Proposal for baseline change from ribbons to fibres in monolithic stage

Mark Barton for the IGR Monolithic Team Systems Meeting 16 April 2008 G080254-00

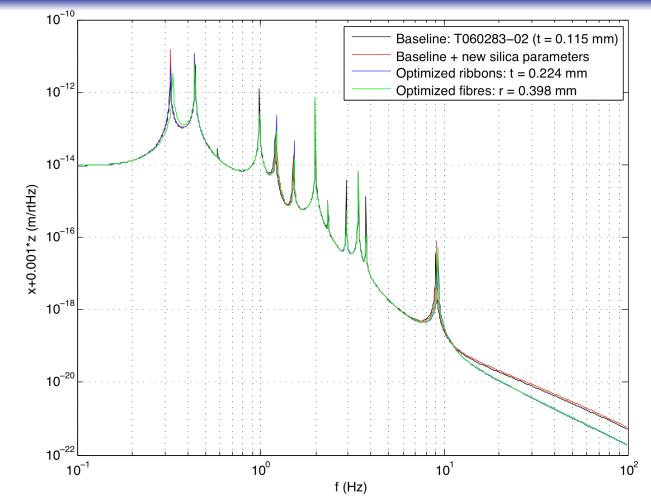
- Optimum dimensions for noise are thicker but only required near ends
- Violin and bounce mode requirements can be met by dumbelling for either optimized ribbons or fibres
 - Neck region -> 1.5 cm (about 5 flexure lengths)
 - Rest of ribbon/fibre same area as baseline ribbon
- Bounce mode increases slightly:
 - 9.0->9.2 Hz
 - Still OK
- Violin mode also increases slightly
 - Trivial improvement
